B-042.101P(B-042)

DRAWN & DRAFTED BY	peng jing cheng	TOLERANCES		ANGLE:	TITLE:				
		0<L≤4 ±0.1	pin pitch ±0.2	±1°	BOBBIN RM-5				
CHECKED & APPROVED BY		4<L≤16 ±0.2		UNIT:	BOBBIN MATERIAL:	PM9630	UL REC. UL 94V-0		
		16<L≤63 ±0.3		MM				PIN MATERIAL:	CP WIRE
 PIN SHINE INDUSTRIAL CO.,LTD. TEL:886-2-22990545 FAX:886-2-22990546				ORIGIN:	DG	DATE:		DRAWING NO.	REV.
					JUL.29 '2002	P-504		3

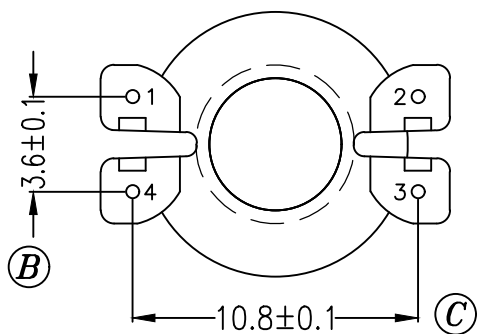
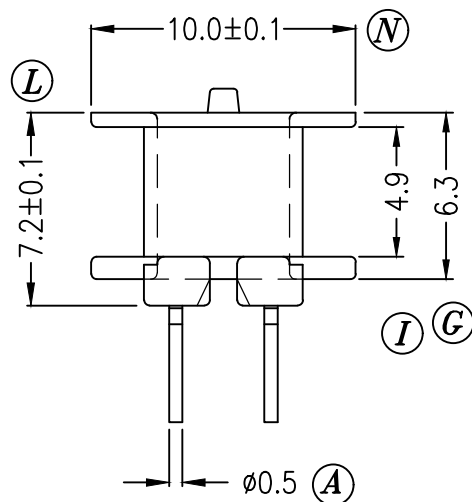
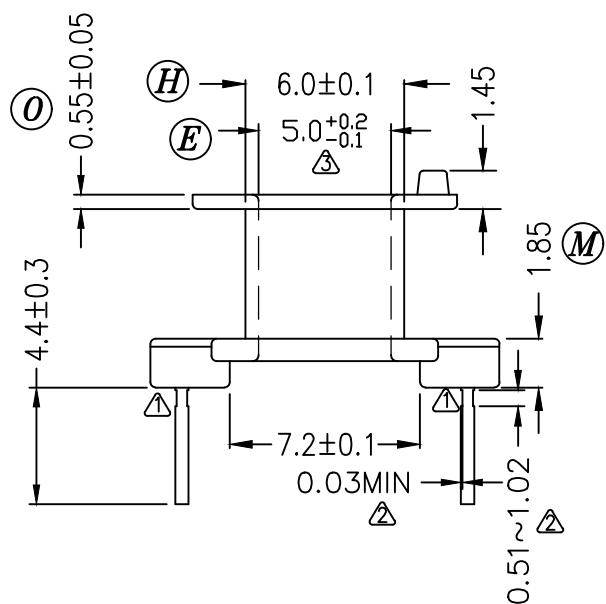
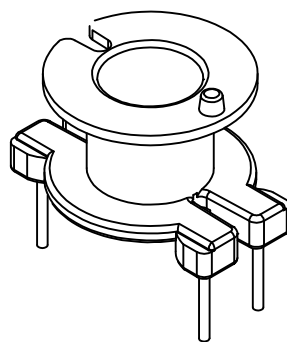
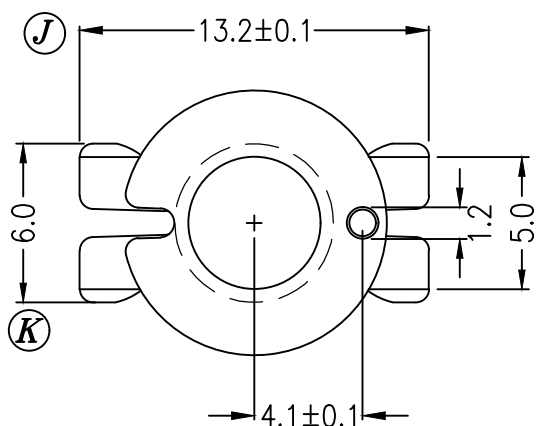
REV.	REVISIONS	REC.	DATE	REV.	REVISIONS	REC.	DATE
1	更新圖檔，PIN根部增加打扁牙 Δ		'06.06.20				
2	增加根部扁牙尺寸 Δ		'09.03.13				
3	修改鐵芯孔尺寸公差 $5.0\pm 0.2 \rightarrow 5.0\pm 0.2/-0.1$ Δ		'13.12.18
